Informal document No. **GRSG-95-31**  
(95th GRSG, 21 – 24 October 2008  
agenda item 3(e))

UN/ECE Regulation No. 107.01

SPANISH COMMENTS ON QUESTION PL1

### **ACCESSIBILITY OF EMERGENCY DOORS FOR MINIBUSES**

Question PL1

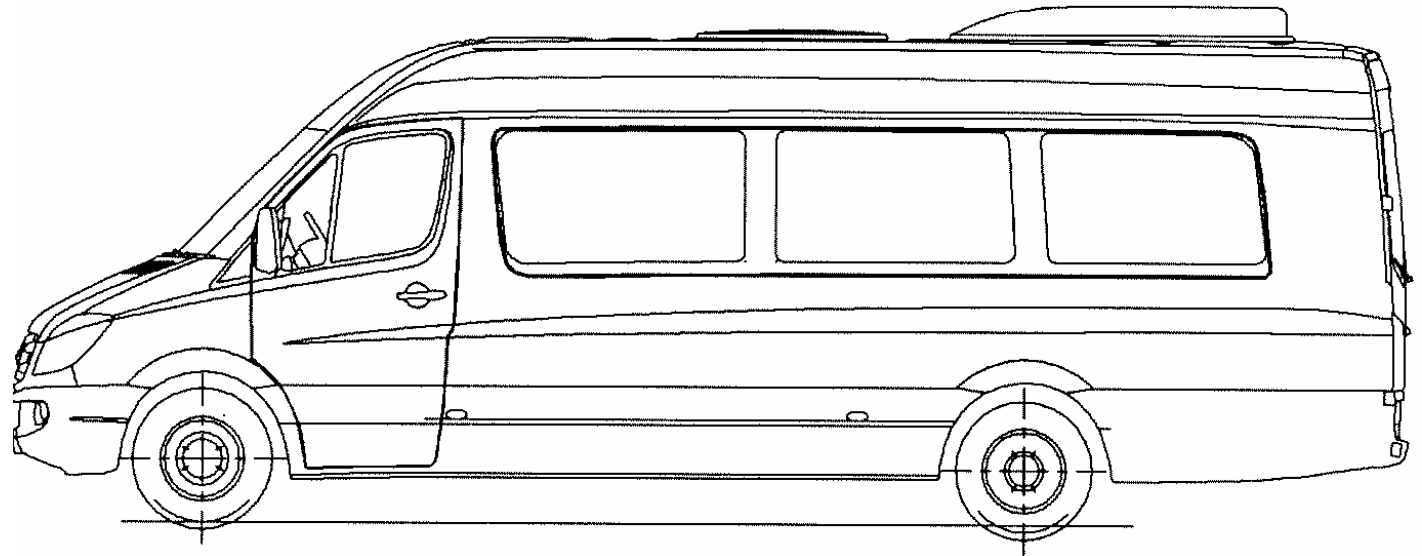
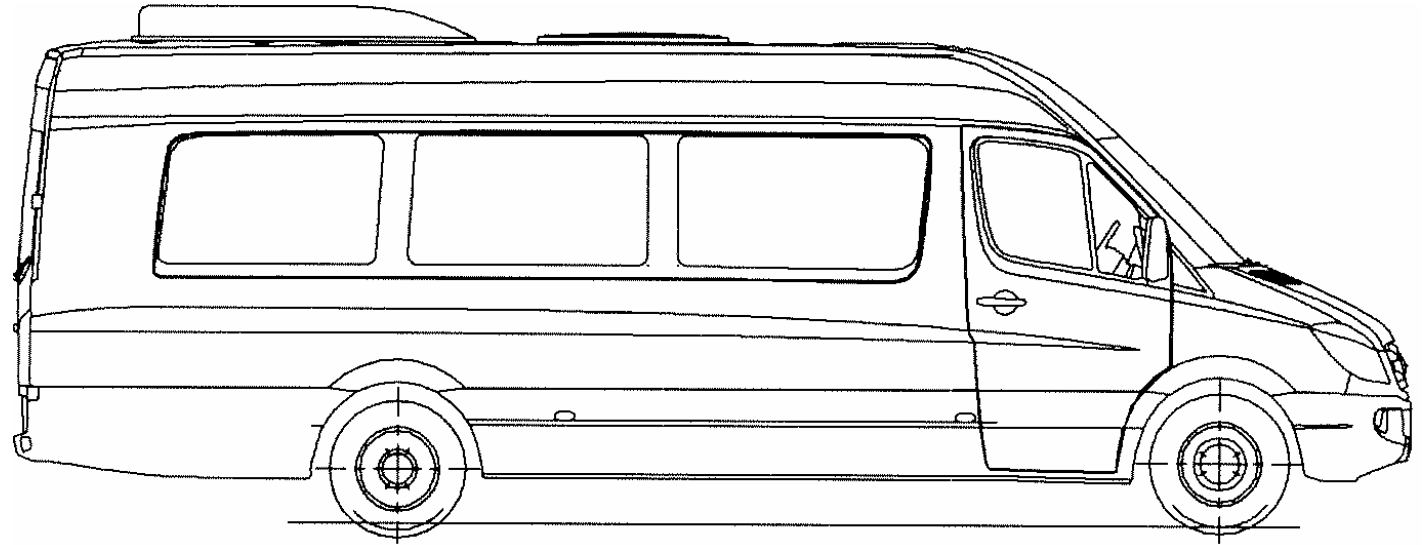
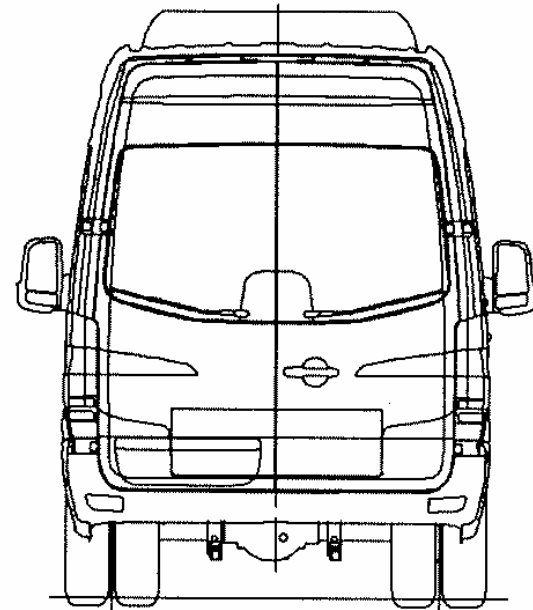
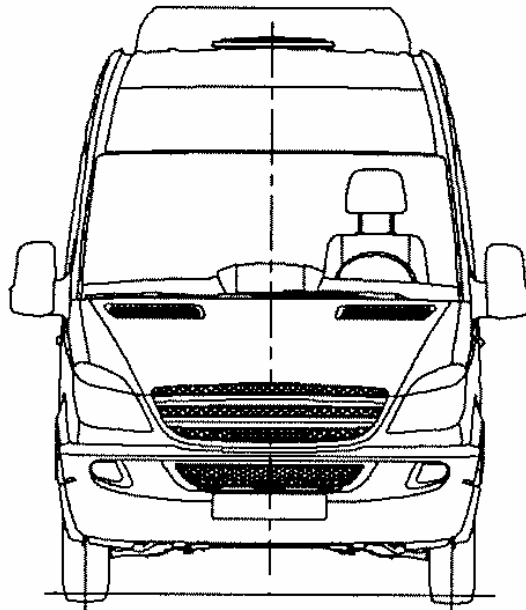
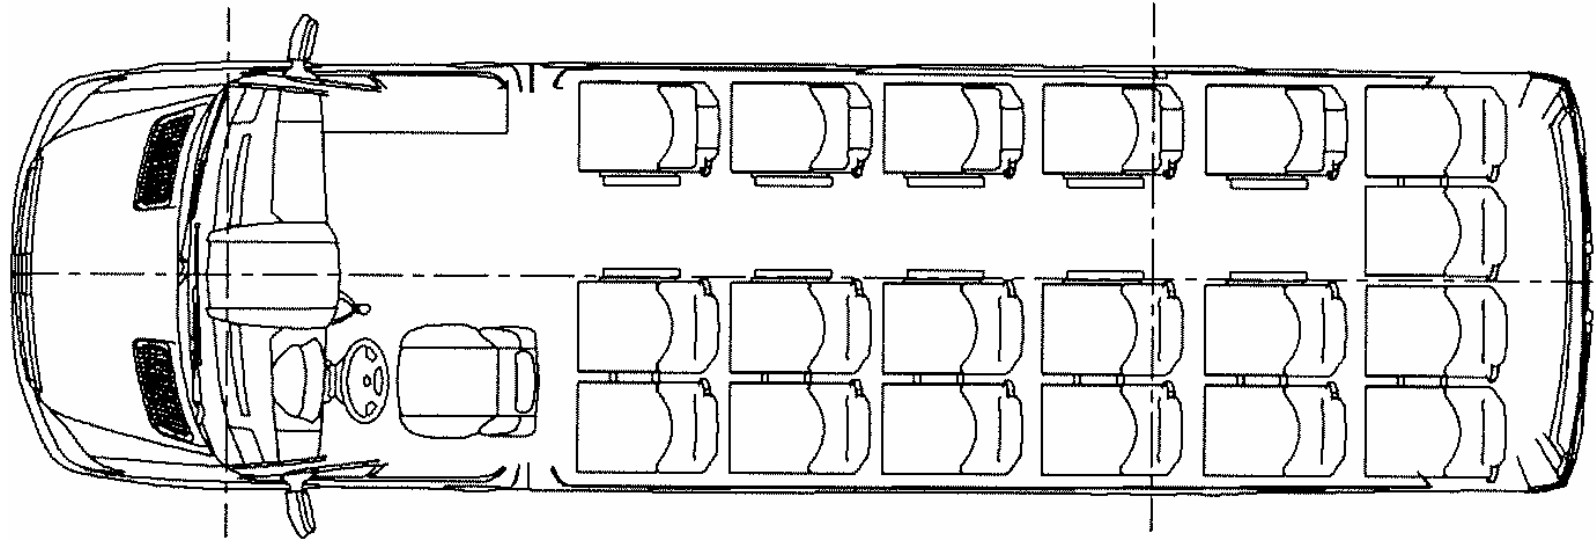
The drawing on the next page shows the vehicle in question. Would such a vehicle configuration obtain a type-approval certificate in your country in respect of the number of service and/or emergency doors?

Regarding TAAM question PL1, Spain considers that the matter was already considered by TAAM in Borlange 2005 meeting and the common agreement was

*“Agree to use the criteria of ECE R52.01 supl 07 (and latter 107.02) to verify the accessibility of the driver’s door to be considered as emergengy door as per 2001/85/EC directive.”*

"Figure 21

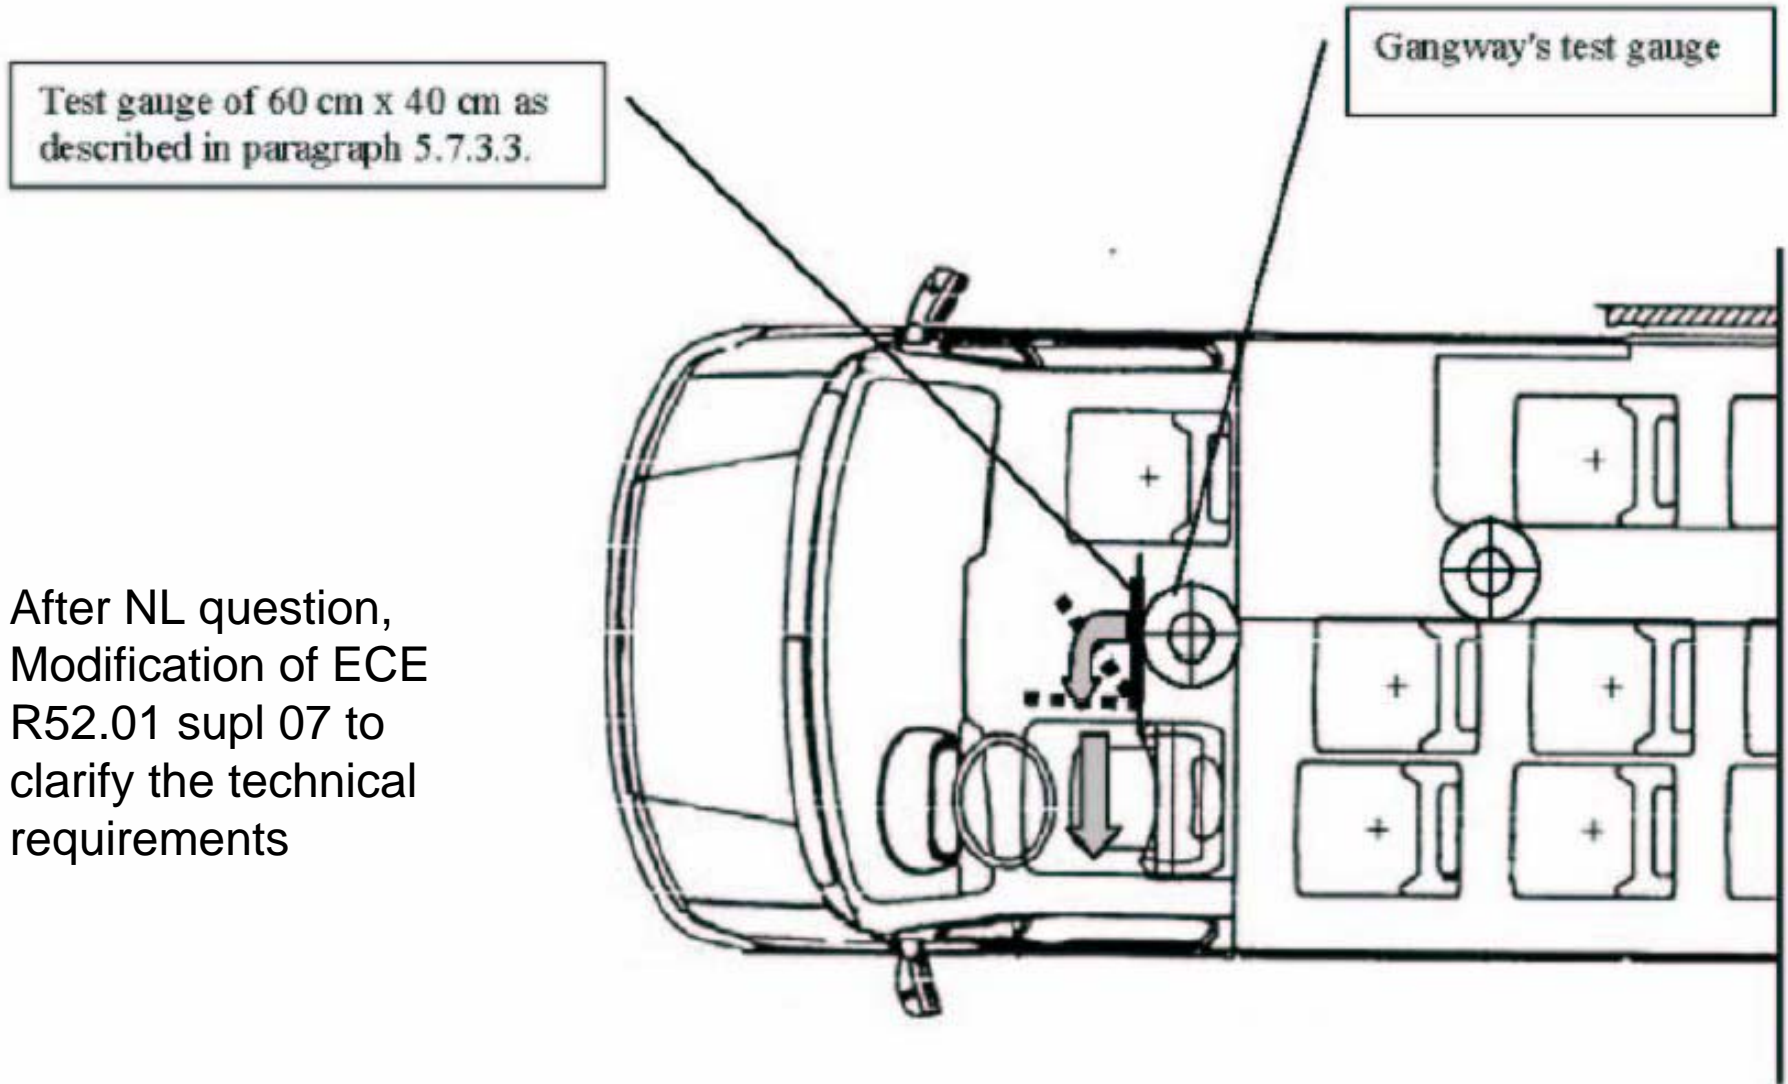
The driver's door shall be accepted as the emergency door for the occupants of the seats situated beside the driver's seat provided that it is possible to move a test gauge from the occupants' seats to the exterior of the vehicle through the driver's door (see annex 3, figure 21).

Verification of the access to the driver's door shall be subject to the requirements of paragraph 5.7.3.2., by using the test gauge having a dimension of 600x400 mm, as described in paragraph 5.7.3.3. The service door provided for the passengers shall be in the side of the vehicle opposite to that containing the driver's door and shall be accepted as the emergency door for the driver;"

Insert new figures 21 and 22, to read:
